**PROPOSAL**

Repairing and painting rotten roof timbers; add an additional two skylights to the loft over the garage and carport; replace windows, relocate one door and replace with a window in ca. 1980 non-historic garage and garage apartment in rear yard of historic house.

**STAFF RECOMMENDATION**

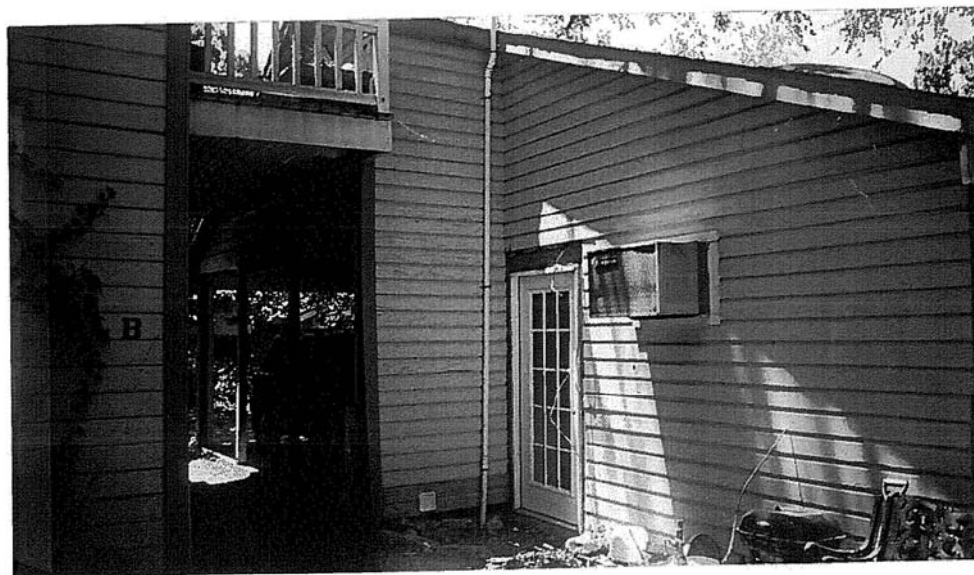
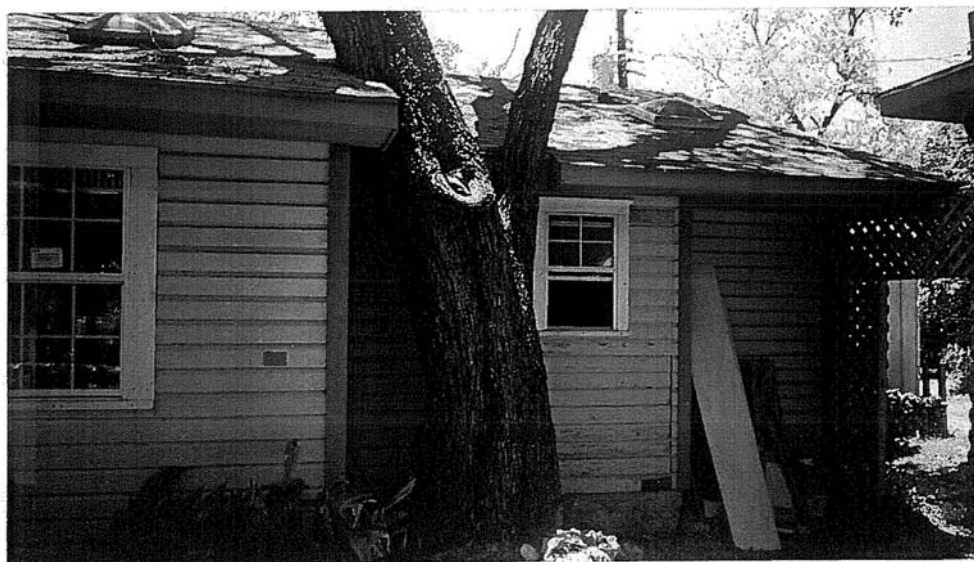
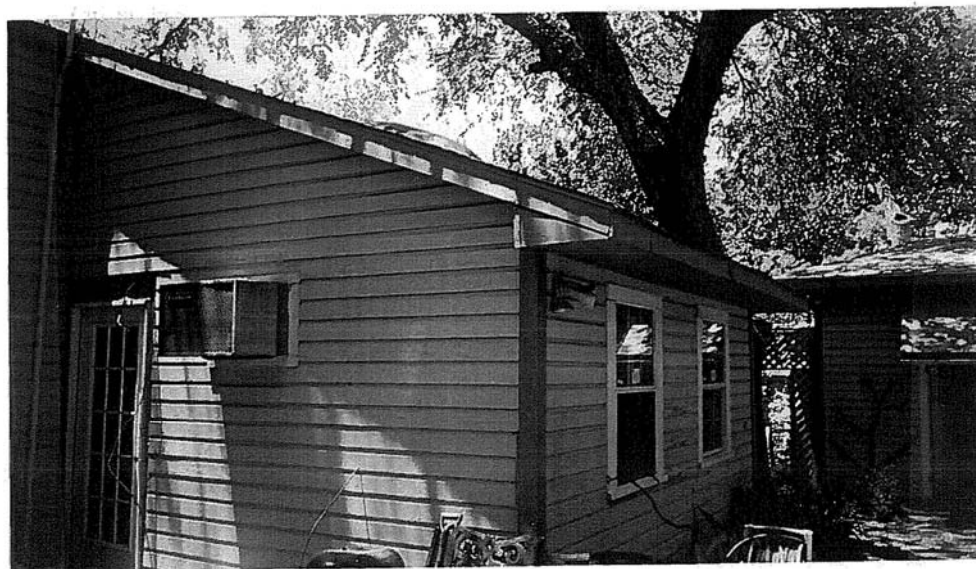
There was some discussion at the Certificates of Appropriateness Committee concerning the application materials for this case. Staff has investigated with the Residential Review Office, which approves building permits for residences, and has ascertained the materials submitted are adequate for obtaining permit approval. Because the plans are hand-drawn on lined 8 ½ by 11 paper, they are somewhat difficult to read. However, given the fact that the proposed work is to a non-historic building on the rear of the lot on which the Landmark structure is located, and the changes being requested do not significantly alter the shape or outline of the non-historic structure, staff has accepted the drawings in this condition for this case only.

Staff recommends approval as submitted.
